CONTENTS			
September 16, 2014			
<u>AGENDA PACKET</u>			
		CAL#	PAGE(S)
	AGENDA		2
	SPRINT	4-14PB	3 - 38
	<i>ACARC Referral 8/20/14</i>		4
	<i>AAB Response 8/26/14</i>		5
	<i>Exemption Request 8/28/14</i>		6 - 7
	<i>Structural Analysis 2/7/12</i>		8 - 24
	<i>RF-EME Compliance Report 2/19/14</i>		25 - 35
	<i>Public Hearing Notice</i>		36
	<i>Public Hearing sign photos</i>		37 - 38
	ESTATE MOTORS	4-13PB	39 - 57
	<i>Cover Letter 8/27/14</i>		40 - 41
	<i>Stormwater Management Narrative Supplemental 8/27/14</i>		42 - 50
	TODD MANAGEMENT SUBDIVISION	5-14PB	53 - 56
	<i>Cover Letter 8/6/14</i>		53 - 54
	<i>Letter to Planning Board from Goldens Bridge Fire Dept. 7/17/14</i>		55 - 56
	JT FARM	9-13PB	57 - 62
	<i>Response to 7/9/14 Kellard Sessions Comments</i>		58 - 60
	<i>Kellard Sessions Memo</i>		61 - 62
	WILD OAKS WATER SYSTEM	51-14WP	63 - 86
	<i>Response Letter - Final 8/27/14</i>		64 - 84
	<i>Kellard Sessions Memo</i>		85 - 86

AGENDA

Tuesday September 16, 2014

321 ROUTE 22
DATE ISSUED: 08/27/2014
FIGURE: DRAINAGE AREA MAP

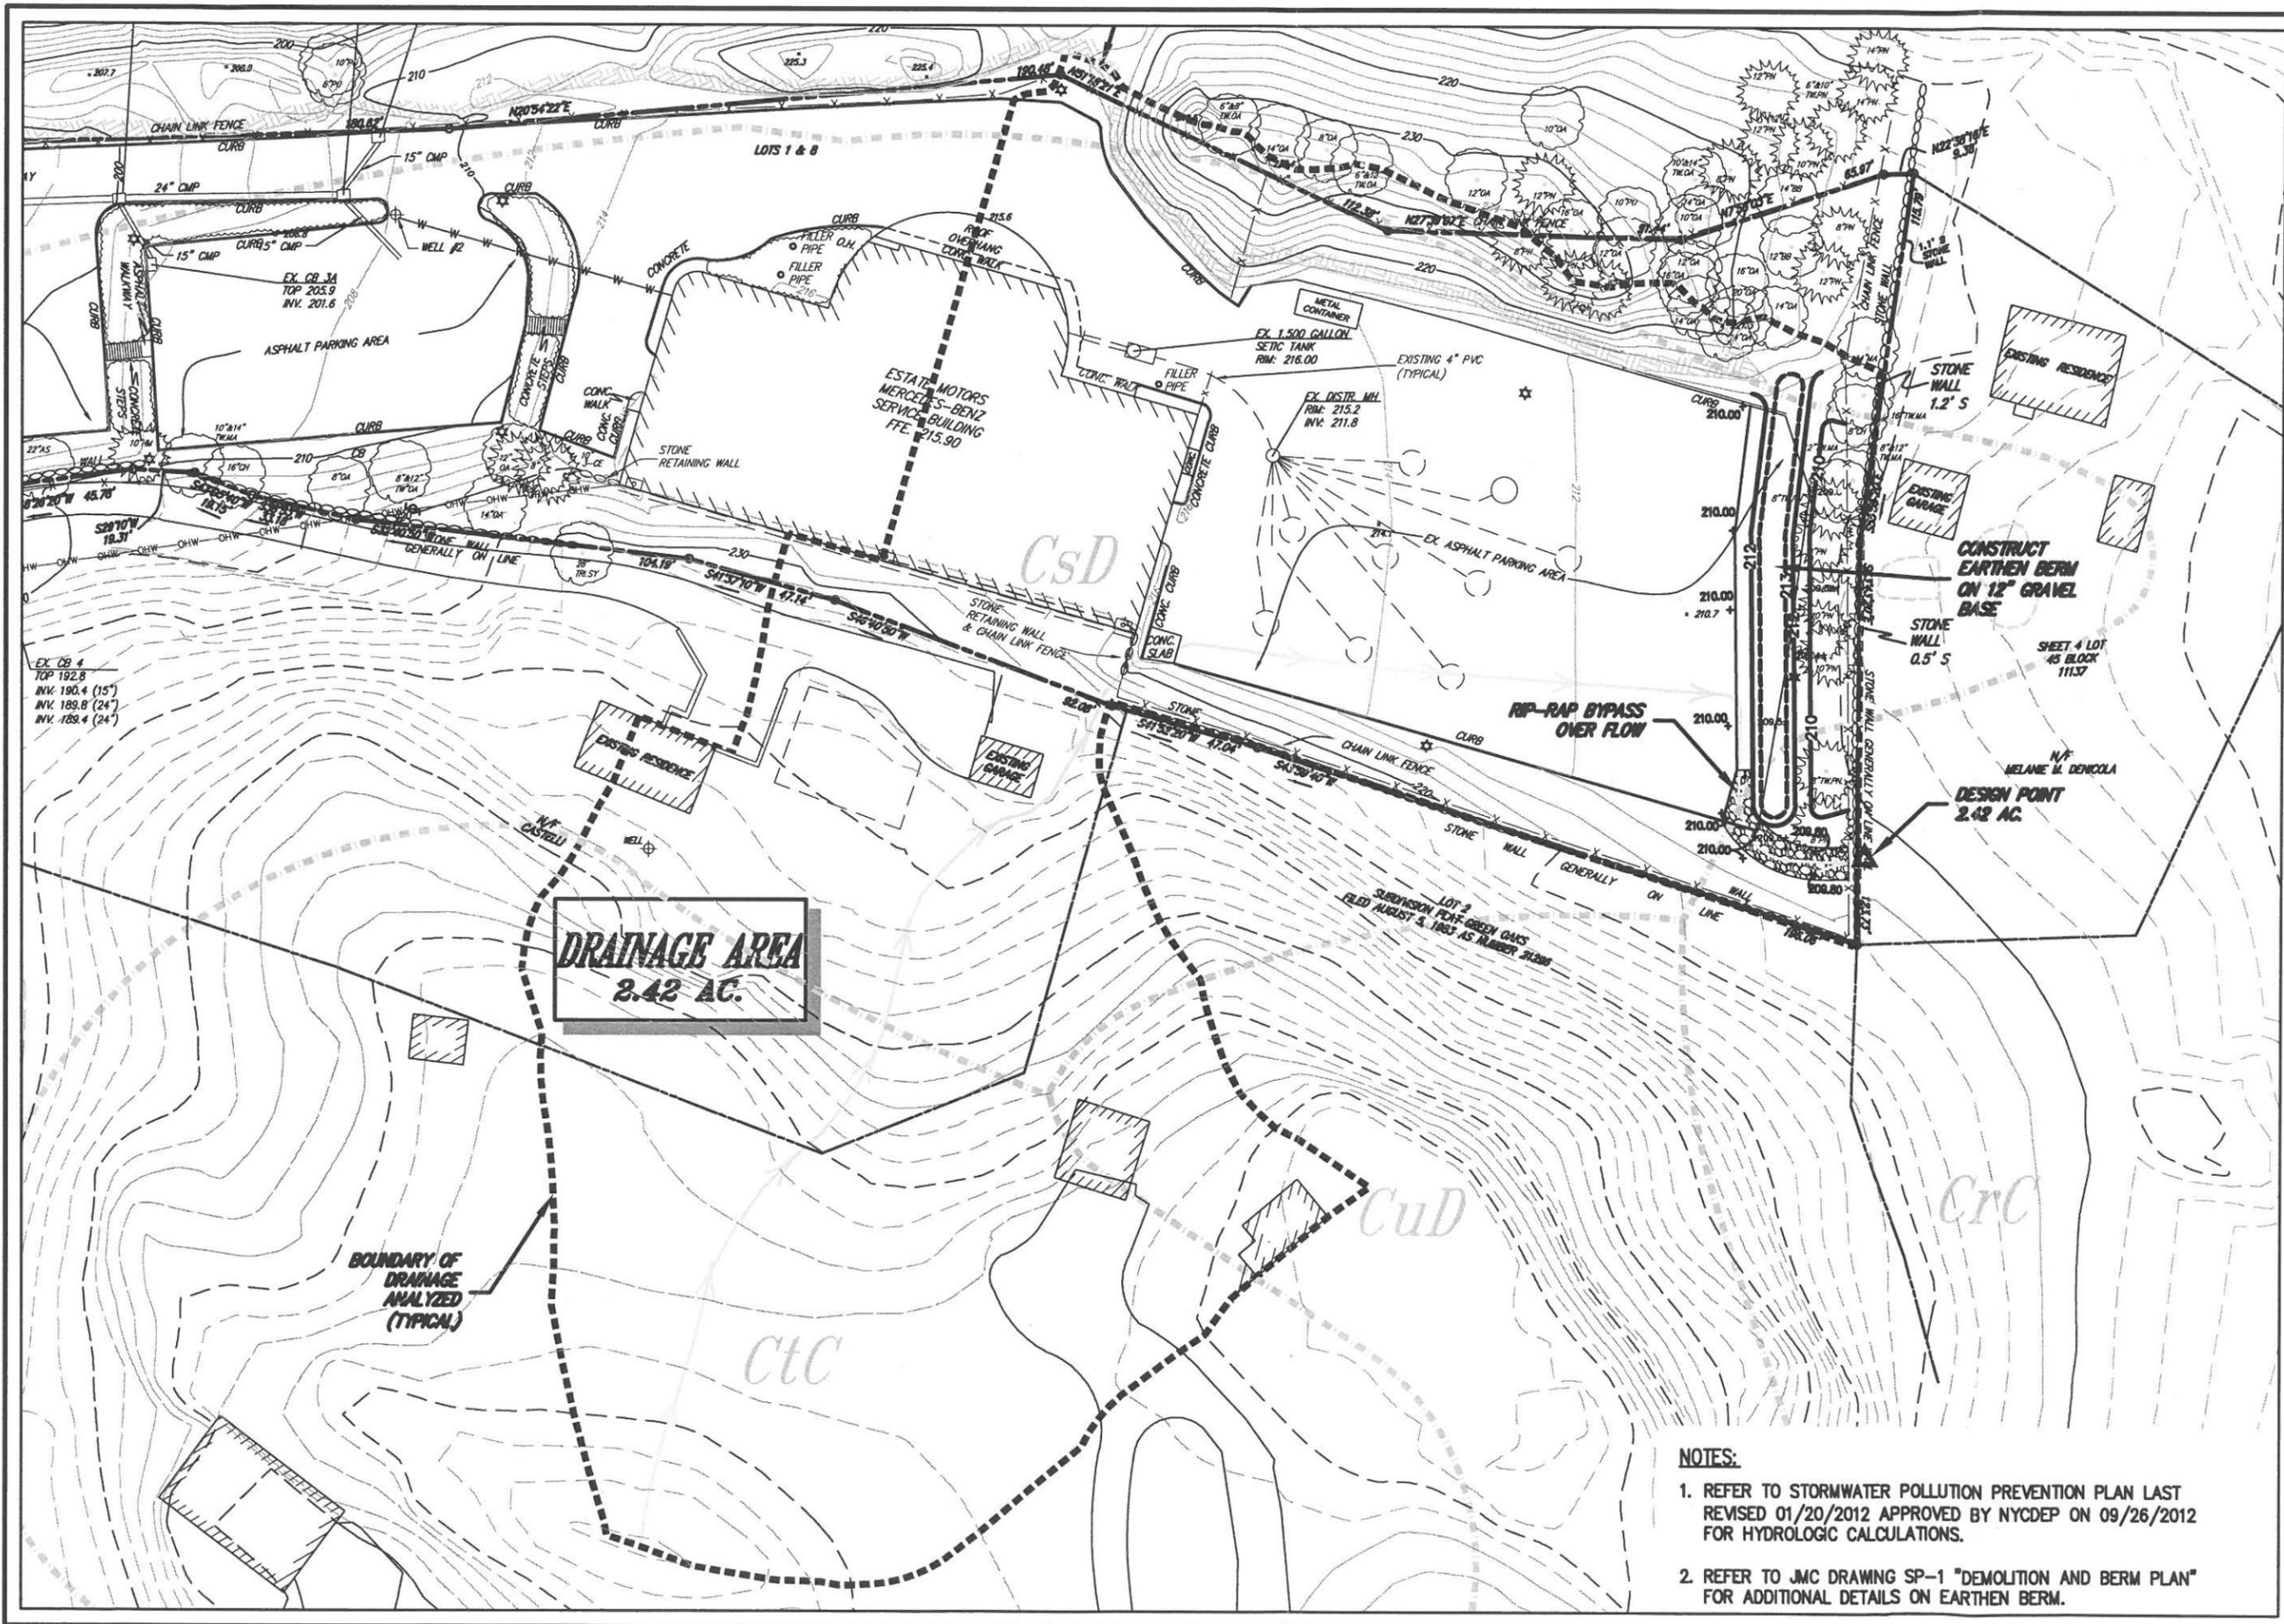
During the Planning Board meeting on August 19, 2014, JMC was asked to demonstrate the ability of the landscape berm to bypass the 100-year storm. This supplemental narrative, supporting calculations and figure were prepared to address the request. During extreme flood conditions (100-year storm) the proposed berm bypass allows runoff to safely pass around the berm and discharge to the adjacent property as it currently does. However, the runoff will be decreased and directed farther from the existing property owner's home.

1. Drainage Area Map Figure, dated 08/27/2014
2. Work Sheet for Trapezoidal Channel, dated 08/27/2014
3. Infiltration Through Gravel Filter in Landscaped Berm Worksheet, revised 08/27/2014
4. New York Standards and Specifications for Erosion and Sediment Control: Standard and Specifications for Lined Waterway or Outlet, dated 08/27/2014.

The Stormwater Pollution Prevention Plan (SWPPP) as approved by the NYCDEP in connection with its review of the previous expansion plan calculated the drainage area flowing to the northern property line. The portion of the analysis for the drainage area is shown on the enclosed "Drainage Area Map" figure, dated August 27, 2014. Approximately 2.42 acres of on and off site area drain to the northern property line which is designated as the Design Point. The approved SWPPP lists the 100 year storm flow for this drainage area as 11.36 cubic feet per second (cfs). The proposed landscaped berm is capable of infiltrating 0.944 cfs as demonstrated in the Stormwater Management Narrative, dated July 31, 2014. Therefore, the remaining flow that will be bypassed is 10.42 cfs.

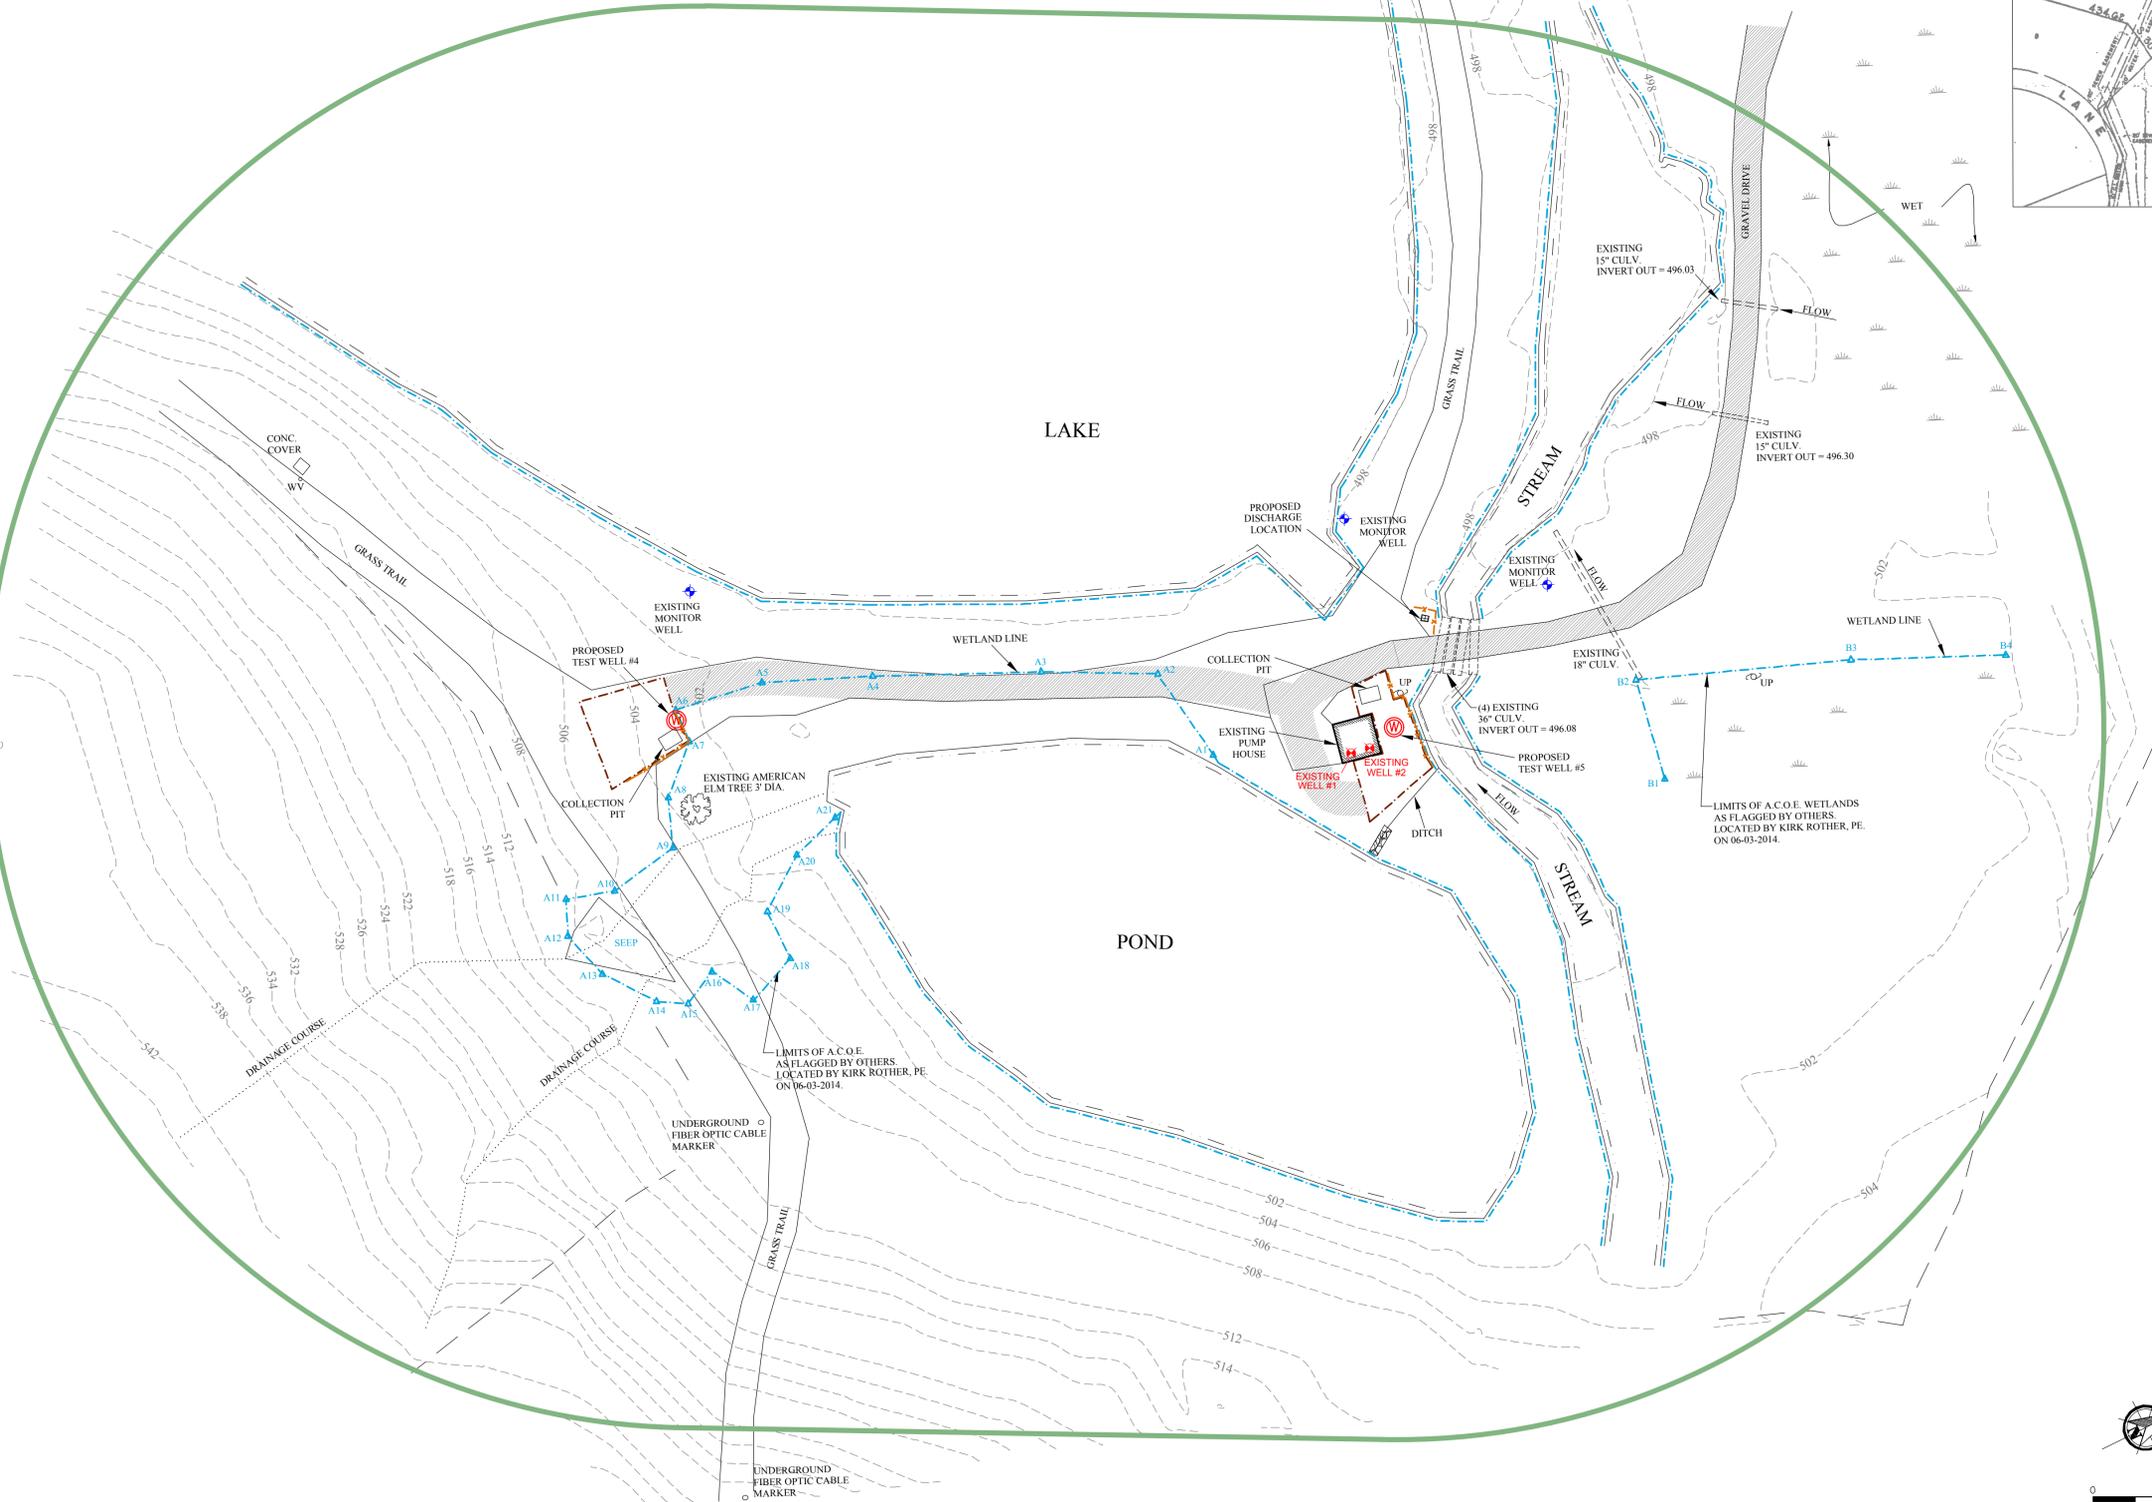
The wetland boundary delineation does not appear to be complete and should include the perimeter of both the ponds, the on-site watercourse, and any other wetlands located in the vicinity of the project. Further, as the entire site consists of either wetland or wetland buffer, the 150-foot wetland buffer line should be removed from the drawing. Following completion of the wetland delineation, a site inspection should be scheduled with our office to confirm the wetland boundary line.

The temporary construction/drill rig access road should be illustrated on the plan. As the wetland boundary line appears to encroach on the existing grass trail which is intended to be

Notes pertaining to the temporary stabilization of the construction access road (the grassed portions) should be included on the plan; the use of temporary mats is preferred.

A note shall be added to the plan stating that all disturbed areas will be raked, seeded and mulched following construction; native seed mix shall be specified.

A note shall be added to the plan stating that the Town Engineer shall be notified 48 hours prior to construction and may inspect and monitor well drilling operations. Further, following completion of work, the Town Engineer and/or Town Wetland Inspector shall conduct a final inspection to ensure that the site has been restored in an appropriate manner.

Haybales tend to contain large amounts of seed, potentially from non-desirable or invasive plant species, and is not the preferred erosion control practice within environmentally-sensitive areas. The use of haybales as an erosion control measure should be removed from the plans and replaced with a suitable alternative.

The banks of the watercourse and the edges of the pond and lake have been designated as a continuation of the wetlands boundary on the attached drawing and the 150-foot buffer line has been removed as requested. During the on-site wetlands delineation, no wetlands fringe was observed along the pond, lake or stream edges in the vicinity of the proposed work except for the wetland fringe that extends beyond the edge of the smaller pond near proposed bedrock test

Well #4. This area was flagged and depicted on the original drawing and is also shown on the attached revised drawings.

The access routes to the proposed well locations have been added to the plan.

A note regarding the temporary stabilization of the access road has been added to the plan. The driller will provide temporary mats to stabilize the road where needed as the drill rig and other equipment is moved onto and off of the site and between the proposed well locations during drilling operations.

A note has been added to the plan stating that all disturbed areas will be raked, seeded and mulched following construction and a seed mix has been specified. Ernst Seed Facultative Wet Meadow Mix (Product ERNMX-122) or its equivalent will be used for reseeding.

A note has been added to the plan stating: The Town Engineer shall be notified 48 hours prior to construction and may inspect and monitor well drilling operations. Following completion of work, the Town Engineer and/or Town Wetland Inspector shall conduct a final inspection to ensure that the site has been restored in an appropriate manner.

Straybales, which have had the seed heads removed, will be used in place of haybales as part of the erosion control. References to the use of haybales in the erosion control have been removed from the plan.
